Application Type: **Replat**
 Status: **First Referral**
 Application Name: Trails at Crowfoot F9 AMD 1 Gas and Convenience Store
 Case/AP#: **SUB22-048**
 Referral Received: October 27, 2022
 Comments Due: November 29, 2022

Application Location: Southeast corner of Bayou Gulch Road and N. Pinery Pkwy
 Review date: **November 10, 2022**
 Plan reviewer: **Randall L. Capra, rcapra@parkeronline.org**
 Phone: 303.805.3163

TOWN OF PARKER - FIRE/LIFE SAFETY:	R REVIEWED FOR CODE COMPLIANCE; REVISIONS REQUIRED
---	---

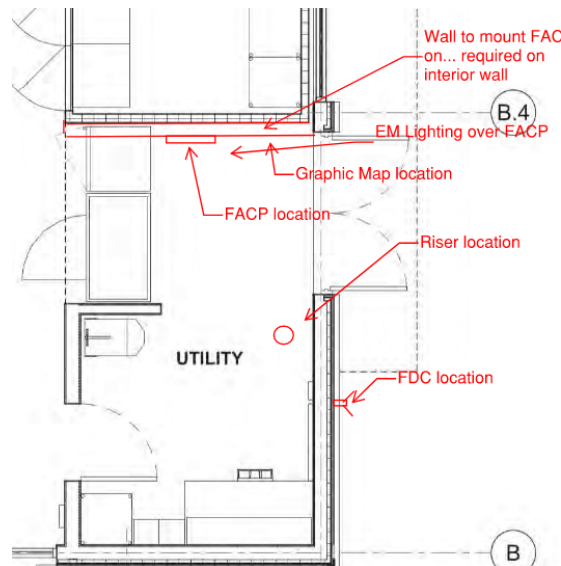
3. Per the requirements of [21 IFC Section 503.1.1 Buildings and Facilities] approved fire apparatus access roads shall be provided for every facility, building, portion of a building hereafter constructed or moved into or within the jurisdiction. The fire apparatus access road shall comply with the requirements of this section and shall extend to within 150 feet of all portions of the facility and all portions of the exterior walls of the first story of the building as measured by an approved route around the exterior of the building or facility (the building, as approximately 4,000

sf (or 40'x 100') cannot meet the requirement as measured from the center line of the fire apparatus as measured by an approved route from any point that a fire engine might park when responding to a call at this building).

Per the requirements of the code, the fire code official is allowed to increase the dimension of the 150 feet provided that the applicant meets Exception 1.1 of this section... "The building is equipped throughout with an approved automatic sprinkler suppression system installed in accordance with section 903.1.1, 903.1.2, or 903.3.1.3; a sprinkler suppression system will be required. The building is to be sprinkled for pre-application meeting discussions. *Satisfied; applicant has acknowledged or addressed with second submittal.*

Example of room layout... ensure that all requirements noted above are met:

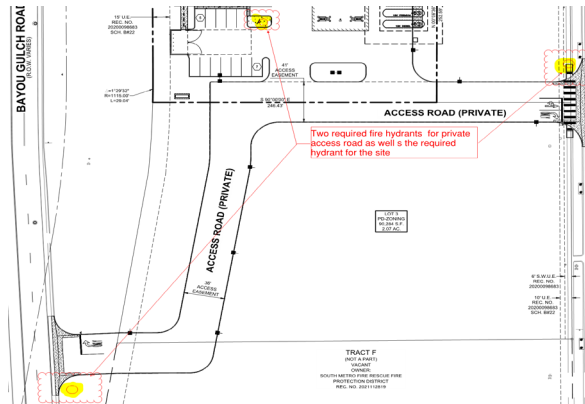
4. The applicant shall provide a room layout that (in advance of a plan set for the commercial building permit) to ensure that the riser room is sized appropriately. With regard to the fire sprinkler control valve room, ensure that the following is addressed: *Not satisfied; the only plan that I found of the interior of the building was on Sheet 16 of 17 in the Site Plan set. This plan showed the entry into the building and a Utility room without showing the locations of the riser and the fire alarm control panel. This room layout is a requirement of Fire Life Safety and must be addressed prior to signoff of the Site Plan. The "fit test" is required to ensure that there is no conflict at time of building review. Address this issue as required. Not satisfied with the third submittal; applicant has not noted or acknowledged or addressed as required.*

- Exterior access is required into the riser room with access into the building provided either adjacent to the riser room or through the riser room.
- The FACP will be required to be located on an interior wall in the fire sprinkler control valve room; ensure that the riser room is sized to accommodate the FACP and the riser. A three-foot clearance is required in front of the FACP as well as the sprinkler riser.
- The underground shall enter the building and turn up no further than 24 inches from foundation wall; three feet of clearance is required in front of the fire riser with a minimum of 12" of clearance behind the riser and 18" to each side of the riser.

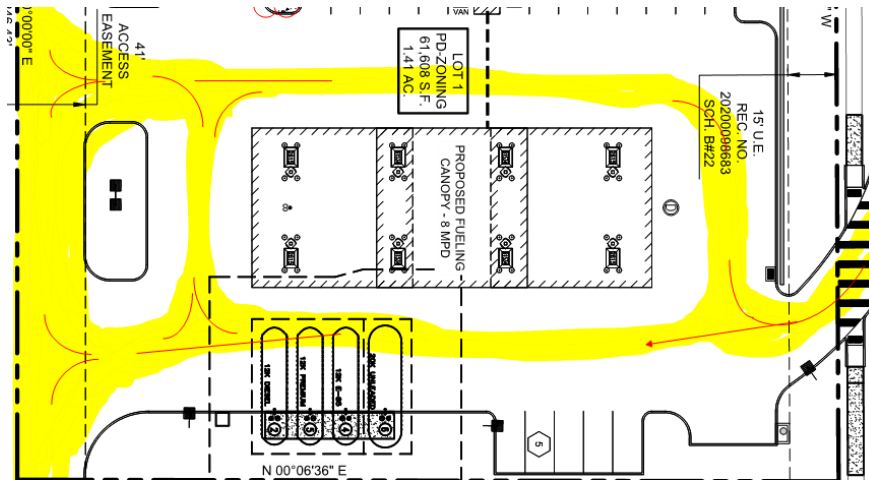
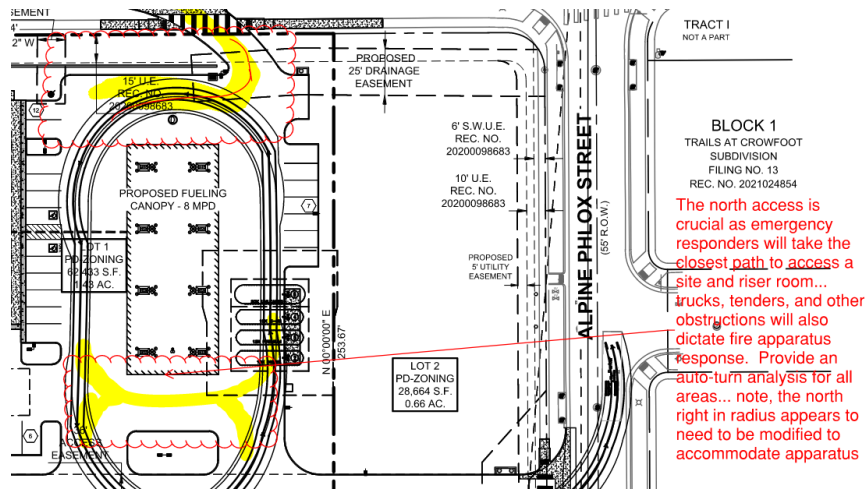
- The applicant shall provide an auto turn analysis indicating that apparatus can navigate all portions of this site (both sides of the gas canopy); NO PARKING – FIRE LANE signage is required for any portion of the access where the 20-foot clear width requirement cannot be met. This is applicable for the loop around the canopy as well as for each entry. The access on each side of the canopy shall meet his requirement with no portion of the canopy encroaching into the required fire lane access road. See below for the areas required to be included in the auto turn analysis and address when resubmitting (failure to address all locations will result in a delay in approval for this project: ***Not satisfied; in addition to what was provided, the applicant shall address what was required... see below... there are two area where the applicant has not provided the auto-turn analysis as required; see below and address when resubmitting;***
